#### **Addendum 94 – UN Regulation No. 95**

#### **Revision 2 - Amendment 5**

04 series of amendments – Date of entry into force: 3 January 2021

#### **Uniform provisions concerning the approval of vehicles with regard to the protection of the occupants in the event of a lateral collision**

Model A  
(See paragraph 4.5. of this Regulation)

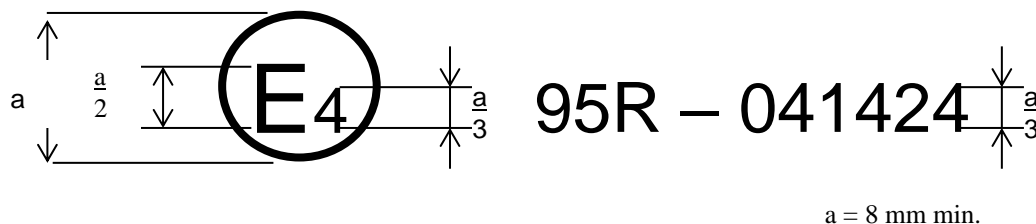
Annex 2, amend to read:

The above approval mark affixed to a vehicle shows that the vehicle type concerned has, with regard to the protection of the occupants in the event of a lateral collision, been approved in the Netherlands (E 4) pursuant to UN Regulation No. 95 under approval number 041424. The approval number indicates that the approval was granted in accordance with the requirements of UN Regulation No. 95 as amended by the 04 series of amendments.

Model B  
(See paragraph 4.6. of this Regulation)

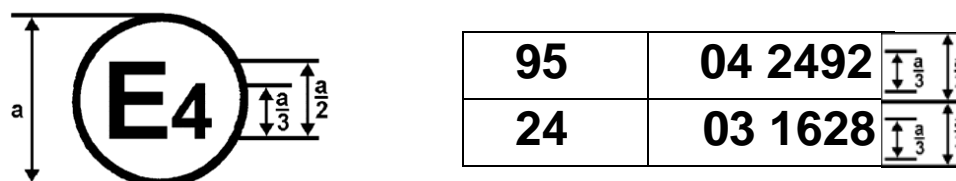
The above approval mark affixed to a vehicle shows that the vehicle type concerned has been approved in the Netherlands (E 4) pursuant to UN Regulations Nos. 95 and 24.<sup>2</sup> The first two digits of the approval numbers indicate that, at the dates when the respective approvals were granted, UN Regulation No. 95 incorporated the 04 series of amendments and UN Regulation No. 24 incorporated the 03 series of amendments."
